ADDENDUM No. 2
West Municipal Complex Site Improvements

CITY OF OREGON
DEPARTMENT OF PUBLIC SERVICE

TYPICAL SECTIONS

CITY OF OREGON
REGIONAL RETENTION POND

PIPE OUTLET DETAIL

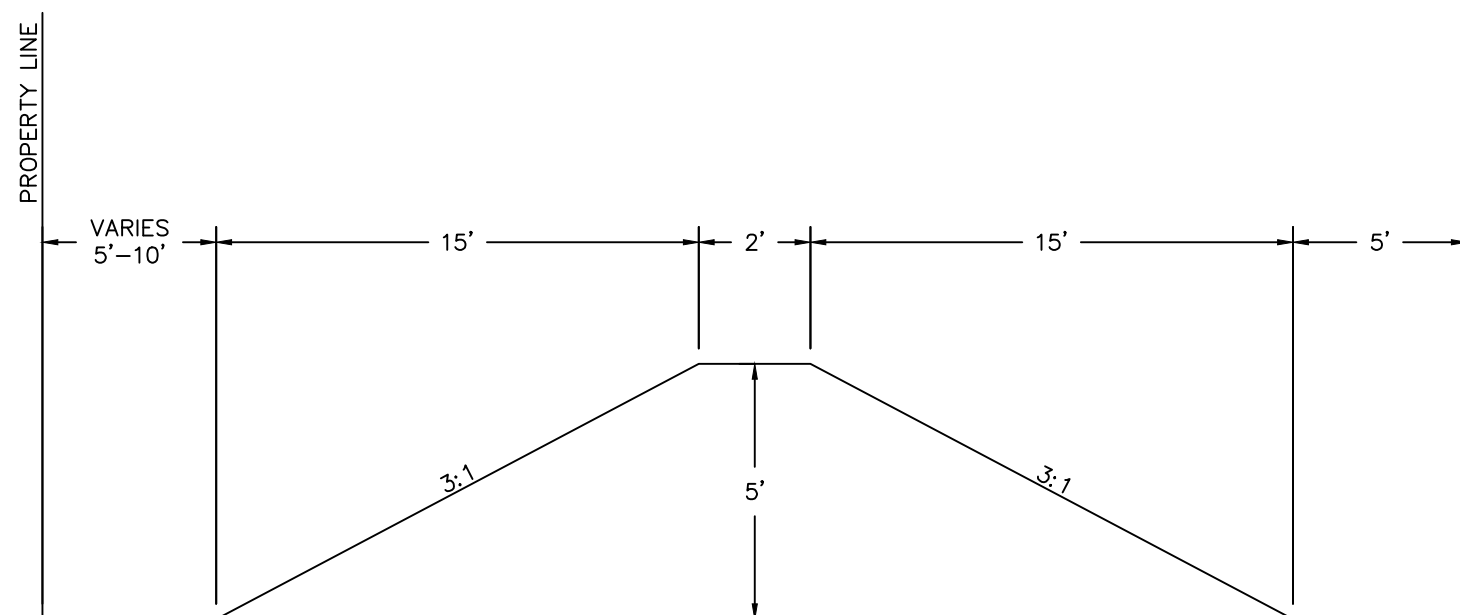
Question #3 – Will pipe material other than RCP be considered for the runs that are called out as RCP?

The last 16' of pipe at the outfall to the pond must be RCP. Other materials may be used for the rest of the run. See detail on revised plan sheet #3.

NOTE: COST OF MATERIALS TO CONVERT FROM 706.02 TO
OTHER MATERIAL OF PIPE TO BE INCLUDED IN COST OF
STORM SEWER, TYPE C (706.02)
